**NOTICE OF A REGULAR MEETING
BONDURANT PLANNING AND ZONING COMMISSION
APRIL 14, 2022**

TITLE: -RESOLUTION NO. PZ-220414-12: Regarding recommended approval of the A-3 Auto site plan for an addition at 108 NE Hubbell Avenue

RESOLUTION REGARDING RECOMMENDED APPROVAL OF THE SITE PLAN FOR
THE ADDITION AT A-3 AUTO AT 108 NE HUBBELL AVENUE

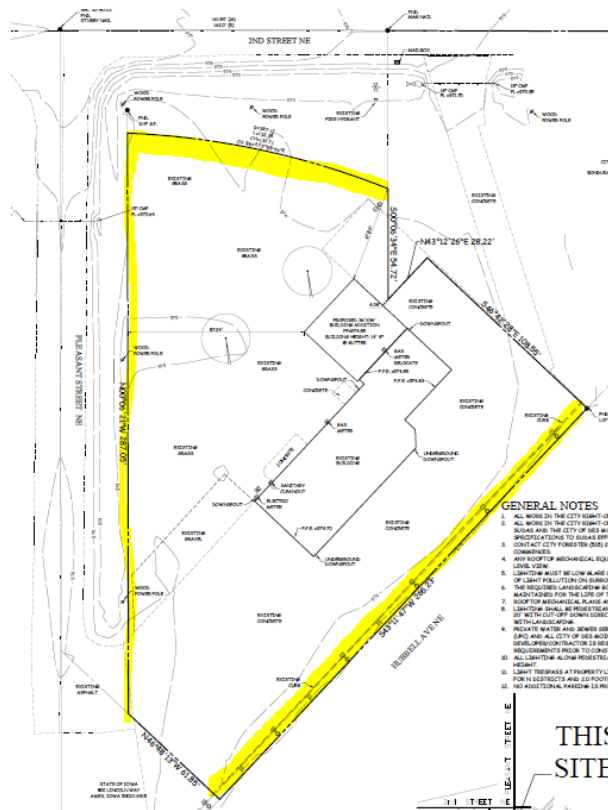
- f. That the property will be surfaced with an asphaltic or Portland cement binder pavement so as to provide a durable and dustless surface. 2022 aerial imagery shows this requirement is not met - see image below showing vehicles parked on dirt/gravel.

SITE PLAN
A3 AUTO

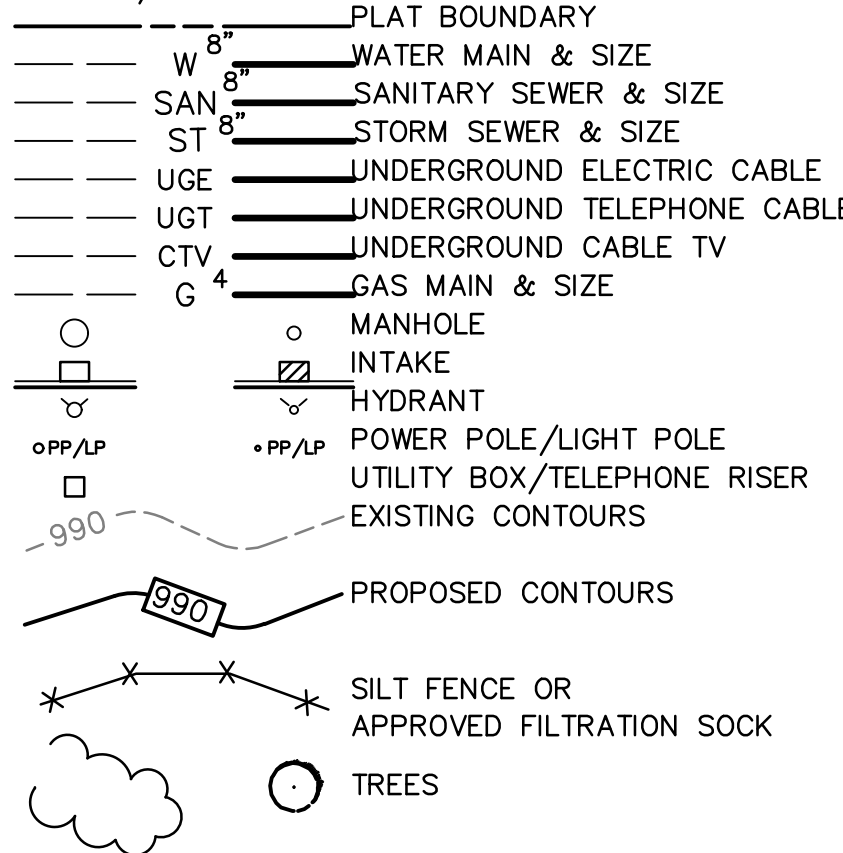
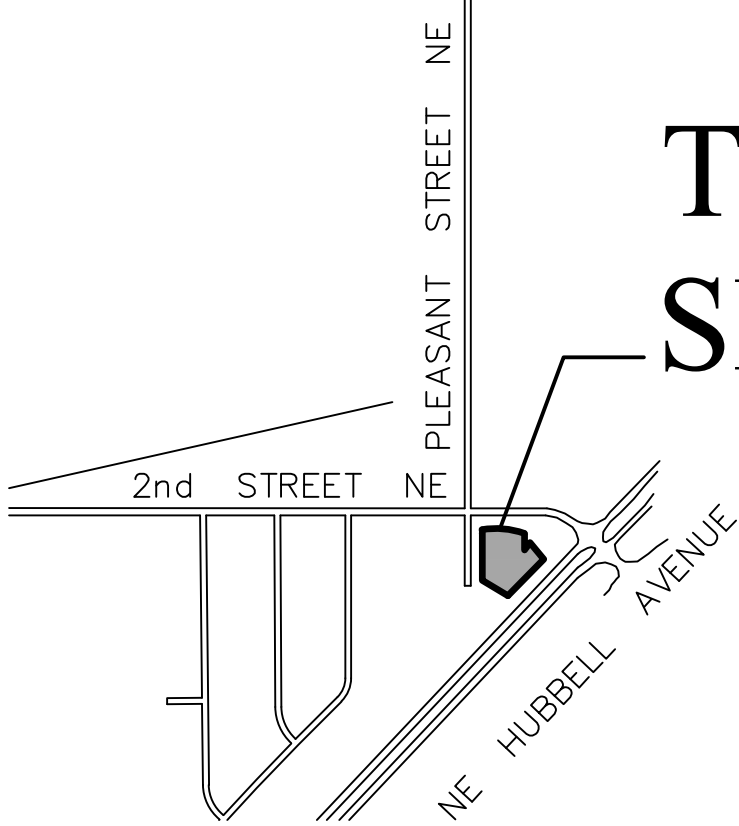
The submitted site plan currently shows no new parking lot paving areas proposed. If any new parking lot pavement is proposed, the site plan must be updated to show this new parking/drive area.

The site plan will need to show that minimum standards for parking lots will be met as a result of this project. Given the existing and proposed square footage, a total of twenty-seven (27) parking spaces are required for the site. Currently, the site plan does not show the location of parking lot spaces, including ADA-accessible spaces, as is required in the code to show. Additional design standards imposed as part of the CUP permitting process include clearly distinguishing between customer parking areas and parking display areas. The site plan currently shows a gravel area which is not a permitted surface for automotive sales permitted by CUP. These additional standards also require the installation of curbs or other substantial permanent barriers to prevent the encroachment of vehicles into the required setback and landscaped areas. Currently, no surfacing or barriers are proposed for the site. In order for the site to continue meeting requirements for the CUP, the subject site will need to comply with these design standards.

Utilities & Easements - no new utility connections from the main into the building are proposed. The submitted site plan does not show any easements on site.

Since this business opened in 2019, a new exterior dumpster is located on site. If an exterior dumpster will remain on site as a result of this project, the location shall be shown on the site plan. The site plan must also note screening proposed. Per Section 178.08.6.B.5 of the Zoning Code, an exterior dumpster must be fully enclosed in an enclosure similar in appearance to the principal structure. This has been factored in as part of the attached resolution.

1. That the applicant must provide answers in writing detailing out how the required Conditional Use Permit design standards noted in the agenda statement will be met as a result of this project prior to building permit approval.

2. That if any new parking/drive areas are proposed as a result of this project, the site plan shall be updated to show these locations.
3. That the site plan must be updated to show that all parking space areas will be striped.

4. That the site plan must be updated to show that minimum ADA parking space count requirements will be met.
5. That the site plan shall be updated to include a landscaping plan showing compliancy with the City of Bondurant's landscaping requirements, and that if any vehicle service bays are proposed to face out toward a public street, the landscaping plan must show how these bays will be substantially screened from view of the street areas.

7. That the site plan must be updated to show that the dumpster will be fully enclosed in an enclosure similar in appearance to the principal structure (requirement of the Conditional Use Permit).
